Access Compliance Report

Public Rights-of-Way

Intersection ID: 7131	Main Street: N_TRYON_ST	Cross Street: ORCHARD_TRACE_LN	Location: S
ADA ID: B2962CD09BC3	Ramp Type: BlendTrans2	Initial Pass/Fail: Pass	Overall Compliance: No
		Severity Score: 5

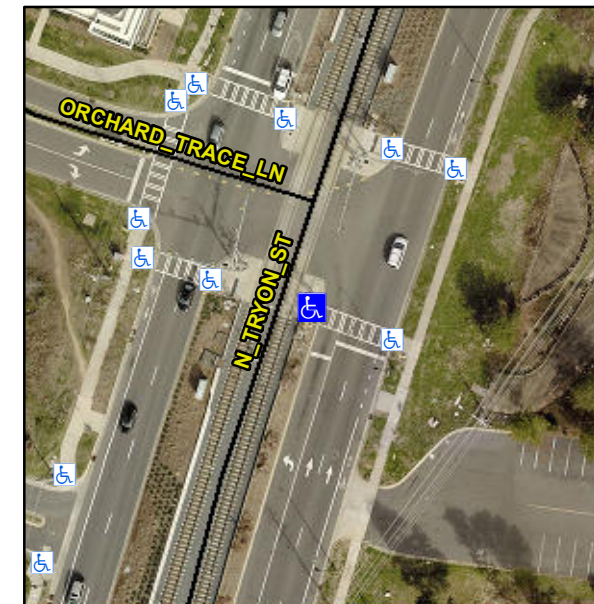
Compliance	Description	Data	Compliance	Description	Data
N/A	Ramp Length (in)	66.0	Yes	BlendTrans Slope (%)	1.7
Yes	Ramp Width (in)	122.0	Yes	BlendTrans XSlope (%)	0.7
Yes	Flare Type	Curbed_NoWalkSurface	No	Flare Type	Curbed_WithWalkSurface
N/A	Flare Slope LT (%)	N/A	N/A	Flare Slope RT (%)	N/A
N/A	Flare Traversable LT?	No	N/A	Flare Traversable RT?	No
N/A	Landing Length (in)	N/A	Yes	DWS Provided?	Yes
N/A	Landing Width (in)	N/A	Yes	DWS Contrast?	Yes
N/A	Landing Slope (%)	N/A	Yes	DWS Length (in)	24.0
N/A	Landing X Slope (%)	N/A	Yes	DWS Full Width?	Yes
N/A	Landing Curb? (Y/N)	No	Yes	DWS Offset (in)	0.0
N/A	Shared Landing?	No			
Yes	Gutter Ponding?	No	Yes	Gutter Slope (%)	0.8
Yes	Gutter Lip Ht (in)	0.0	No	Gutter X Slope (%)	2.5
N/A	Painted X Walk1?	Yes	N/A	Painted X Walk2?	N/A
	X Walk 1 Direction	To E		X Walk 2 Direction	N/A
	X Walk 1 Width (in)	107.0		X Walk 2 Width (in)	N/A
	X Walk 1 Slope (%)	1.8		X Walk 2 Slope (%)	N/A

Possible Solutions:

**Remove & Replace Curbed Edge.
Remove & Replace Gutter.**

R304.2.3, R304.5.3
